Planned document changes:

Std. Hitch components - S70

EC326, EC333, Machine hitch

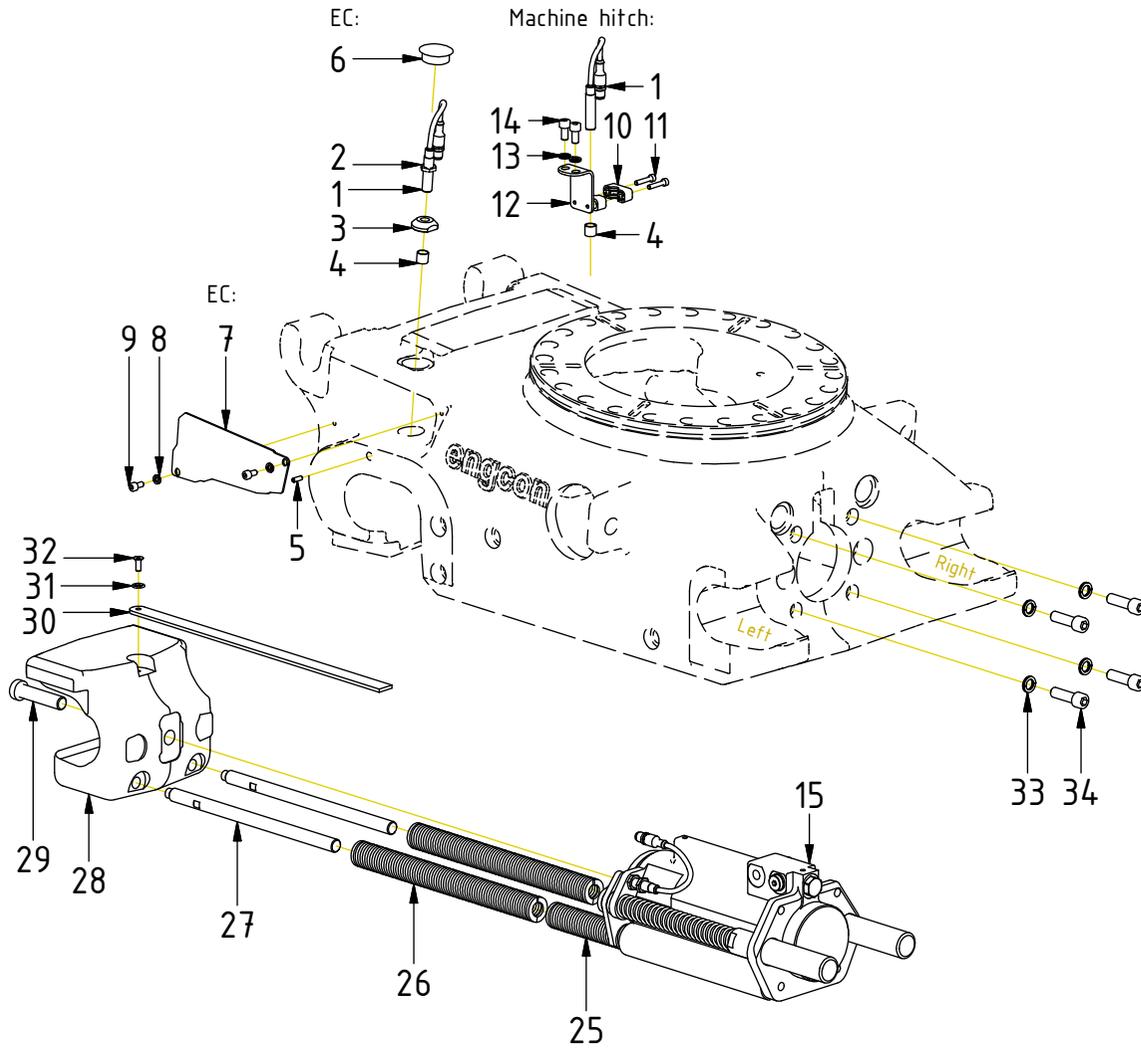
2026-03-19. For EC326: POS.3, 5, 6 & 7 expires. Compatible with previous EC hitch.
Add instead POS.10 & 11. 1068462 replaces POS.6, 1074156 replaces POS.7.
EC333 and Machine hitch remains the same.
